# RHODE ISLAND CONVENTIONS CENTER AUTHORITY

<b>ADDENDUM #4</b>
--------------------

**Title: Garrahy Courthouse Parking Garage #GCG2018**

QUESTIONS		ANSWERS
1.	Please provide the architectural color renderings which were displayed in your presentation this morning at the Garrahy Courthouse Parking Garage Pre-Bid Conference.	See color renderings attached to Addendum # 2

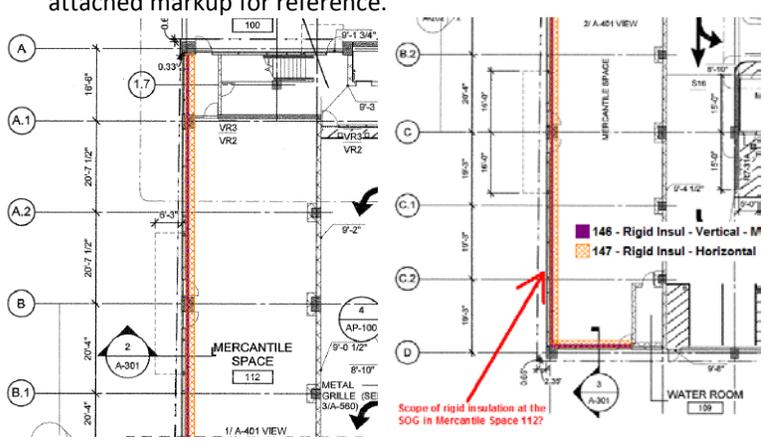
86.	Aluminum Trusses Section 004100 Bid Form and Section 054400 Cold Formed Metal Trusses and Drawing A321 (facade details) Alt #2 and det 6/A-321	<b>Back-up framing for the exterior gypsum sheathing and phenolic wall panel cladding system is to be a "Performance Design" by the contractor. The base bid is to be</b>

QUESTIONS		ANSWERS
	(typical) Alternate No. 2 requires bidders to provide all-aluminum truss framing support for the system of phenolic wall panels and gypsum sheathing in lieu of galvanized steel truss framing support. However, details on drawing A-321 indicate the base material would be aluminum. Could you confirm that specification 054400 supersedes notes on drawings that indicate aluminum? Please clarify Alternate No. 2 and the base scope for the trusses.	<b>cold-formed galvanized steel framing or trusses and the alternate is for the framing to be all-aluminum trusses (Alt. No. 2).</b>
